# Accessibility Survey

## City of Downey Glynn Avenue - Eucalyptus Street To Cul-de-sac

Date of Inspection  
1/31/2017

Prepared By  
**Disability Access Consultants**  
(800) 743-7067

#### Change In Level North Of Donovan Street @ 33.925360050404, -118.142542988062

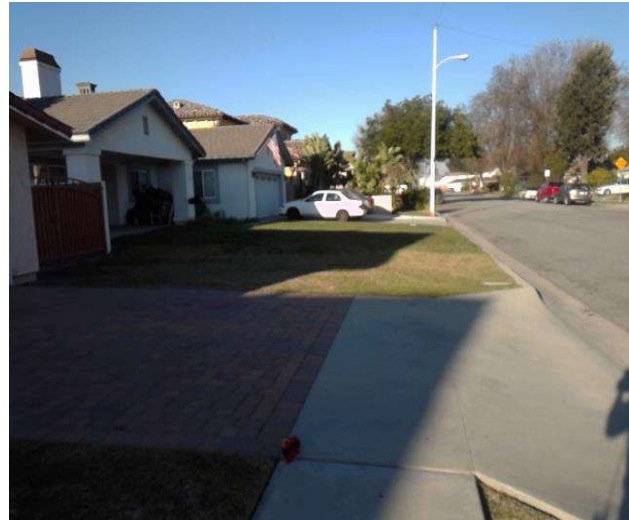
Sidewalks , Change in Level : Change in Level Non Beveled

There is a change in elevation greater than recommended value.

**On-Site Finding** 0.50 inches

Ensure that the change in elevation is within the recommended value.

Recommendation Up to 0.25 inches
